Access Compliance Report Public Rights-of-Way (Curb Ramps)

Main Street: ERVIN_LN Cross Street: TEA_HOUSE_ST Location: NW

ADA ID: RPAT211005145857 Ramp Type: Type 3 - Combination 1 Initial Pass/Fail: Fail Overall Compliance: No Severity Score: 16

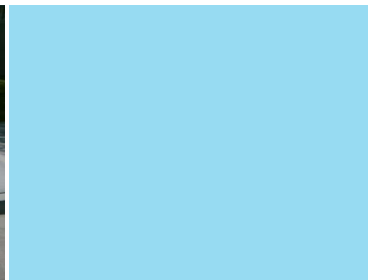
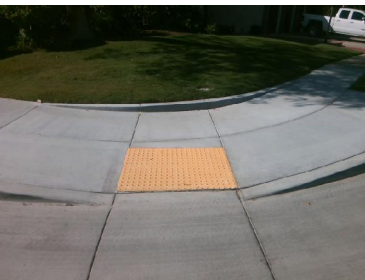
Compliance	Description	Data	Compliance	Description	Data
N/A	Ramp Length LT (in)	70	N/A	Ramp Length RT (in)	78
Yes	Ramp Width LT (in)	49	Yes	Ramp Width RT (in)	48
Yes	Ramp Run Slope LT (%)	1.4	No	Ramp Run Slope RT (%)	8.7
Yes	Ramp Cross Slope LT (%)	0.6	No	Ramp Cross Slope RT (%)	3.3
N/A	Ramp Length (in)	47	N/A	Flare Type LT	
Yes	Ramp Width (in)	48			N/A
Yes	Ramp Run Slope (%)	7.4	N/A	Flare Slope LT (%)	N/A
Yes	Ramp Cross Slope (%)	1.7	N/A	Flare Traversable LT	N/A
N/A	Landing Present	N/A	N/A	Flare Type RT	
N/A	Landing Length (in)	N/A			N/A
N/A	Landing Width (in)	N/A	N/A	Flare Slope RT (%)	N/A
N/A	Landing Run Slope (%)	N/A	N/A	Flare Traversable RT	N/A
N/A	Landing Cross Slope (%)	N/A	N/A	DWS Provided	N/A
N/A	Landing Movement Obstructed?	N/A	N/A	DWS Contrast	N/A
	Landing Movement Type	N/A	N/A	DWS Length (in)	N/A
N/A	Landing Shared	N/A	N/A	DWS Full Width	N/A
N/A	Clear Space	Yes		DWS Offset Type	N/A
N/A	Clear Space To Crosswalk (in)	N/A	N/A	DWS Offset Left (in)	N/A

Remove & Replace Curb Ramp With Two New Directional Ramps or Equivalent.

R304.3.2, R304.5.3, STD 1115
